TECHNICAL MEMORANDUM

SUBJECT: Responses to Peer Review Comments - Lake Prevatt HSPF Model

Figure 1. Impacts of Lake Coroni inflow to Lake Prevatt at South Lobe for the period from 2008 to 2020.

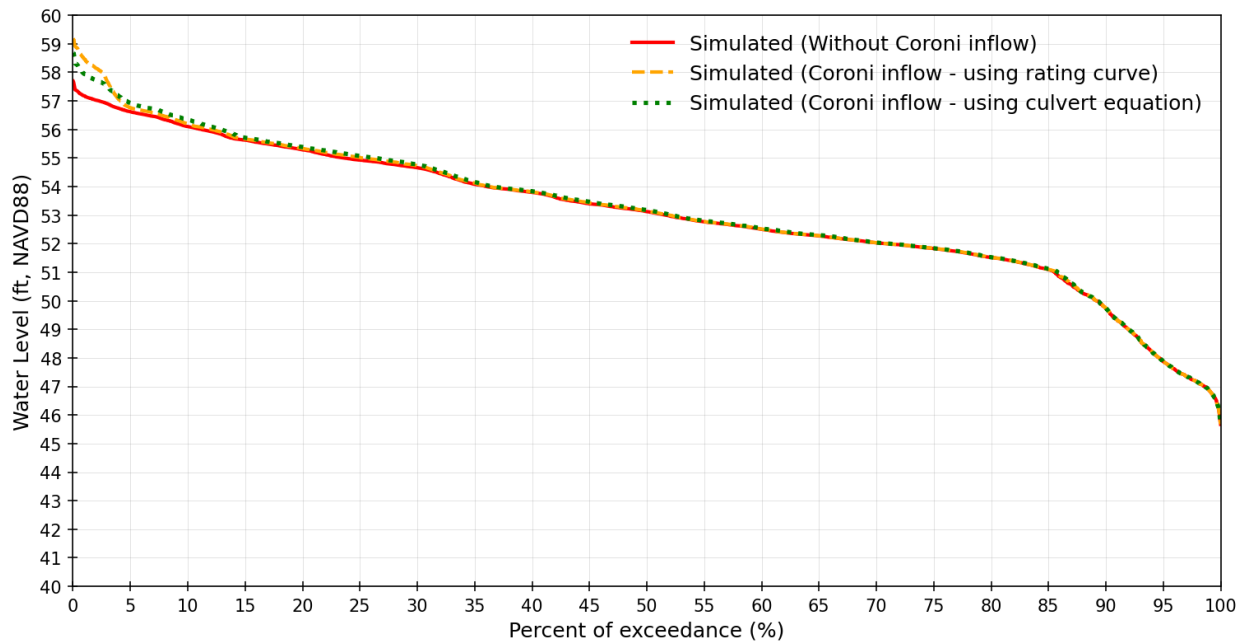
- *Comment 3. In March 1997, Professional Engineering Consultants, Inc., published a stormwater management plan of the surface-water conveyance system that drains to Lake McCoy, Lake Coroni, and Lake Prevatt (**Figure 4**). Professional Engineering Consultants conducted the study for Orange County, the City of Apopka, and SJRWMD. Professional Engineering Consultants field verified the watershed boundary, measured geometry and elevation of stormwater conveyance infrastructure, and measured or estimated geometry and volume of stormwater retention and detention facilities. Professional Engineering Consultants simulated water-surface elevations at selected locations in the watershed, such as in lakes and stormwater retention facilities; and flow rates in selected surface-water conveyance features, such as culverts and channels. Professional Engineering Consultants simulated flows between Lake McCoy, Lake Coroni, and Lake Prevatt. Geosyntec Consultants attach Professional Engineering Consultants (1997a) to this technical memorandum. SJRWMD did not simulated flows from Lake Coroni to Lake Prevatt*

(Figure 2). SJRWMD also did not simulate flows from Lake McCoy to Lake Coroni (Figure 2). SJRWMD may wish to re-delineate the watershed that drains to Lake Prevatt to include areas that drain to Lake McCoy (Figure 5) and Lake Coroni (Figure 6). This re-delineation will conform to observations made by Manager Brooks, that water from Lake Coroni periodically or episodically flows to Lake Prevatt from Lake Coroni. SJRWMD may wish to inform this re-delineation with Professional Engineering Consultants (1997a) and select environmental resource permits

- In response to the review comment, we ran sensitivity scenarios that included estimated discharges from Lake Coroni. We calculated discharges northward into Lake Prevatt and added them to the model as daily time series inflows into the South Lobe. The development of the rating curve utilized stage and outflow values reported for four design storms (mean annual, 10-year, 25-year and 100-year 24-hour storms) in Table 2-4 of PEC (1997a). Two methods were used to estimate discharge northward into Prevatt. First, the computed discharges for these storms were used to create a rating curve that correlated the inflows with stage in the South Lobe. As a cross-check, we also created a second scenario where a hydraulic equation for the connecting circular culvert between the lakes was applied to estimate the flows, again based on the correlation of headwater and tailwater stages. The developed rating curve and circular culvert equation were then used to generate daily time series inflows based on the simulated water levels in the South Lobe. Figure 1 below compares the simulated lake levels exceedance probability curves with and without considering the inflows from Coroni. The flows from Lake Coroni affects only the highest peak water levels with an exceedance probability $\leq 5\%$ in Prevatt. They are not expected to have an impact on the water

levels relevant to the proposed MFLs, which do not address such high stages. Therefore, re-delineating the watershed and re-modeling the headwater stages in Coroni was deemed not relevant for this project.

Figure 2. Impacts of detention storage (DS) and wetland (WTL) storage depth on simulated water levels exceedance probability curves of Lake Prevatt South Lobe for the period from 2008 to 2020.

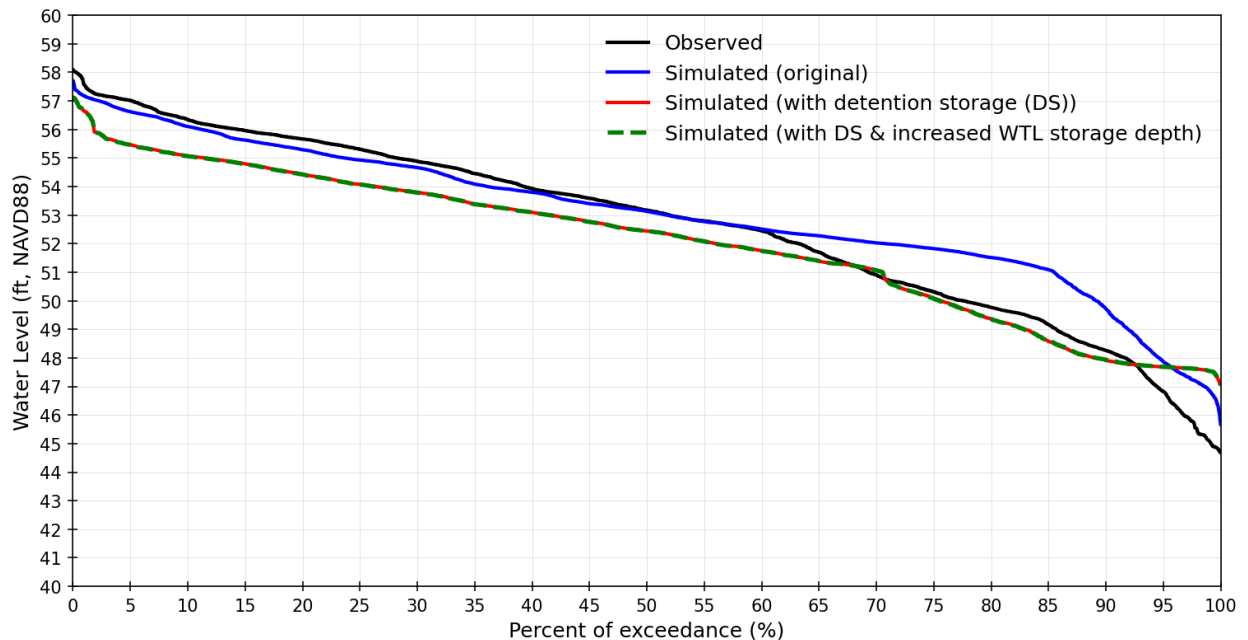
- *Comment 5. Stormwater management systems exist in the Lake Prevatt watershed, which detain or retain stormwater (**Figure 8**) from the watershed to Lake Prevatt. Natural ponds also exist in the Lake Prevatt watershed. These ponds likely retain or detain surface-water flows from the watershed to Lake Prevatt. SJRWMD may wish to revise the simulation to include constructed stormwater management systems and natural ponds, to quantify detention or retention of surface-water flow to Lake Prevatt.*

- In response to this review comment, we ran a sensitivity scenario to increase the detention and retention storage in the watershed. It was done by routing surface runoff from urban lands to the water PERLND segments in the HSPF model, which can act as a detention storage. We also increased the storage depth of wetlands by 17 inches to provide additional potential storage. Figure 2 below compares the simulated lake levels with observed lake levels exceedance probability curves for Prevatt South Lobe. The figure indicates that considering the detention storage could reduce the overestimation of observed lake levels for some low stages in the 70-90 percent exceedance range but increases them noticeably for higher exceedances. At the same time, the medium- to high-level observed water levels are clearly underestimated, and we felt it unlikely that recalibrating the model to raise the medium to high range would resolve the issue any better. As it stands, the model parameters for the uplands implicitly account for the impact of detention on the overall runoff, and we feel that this is sufficient for the purpose of the model.
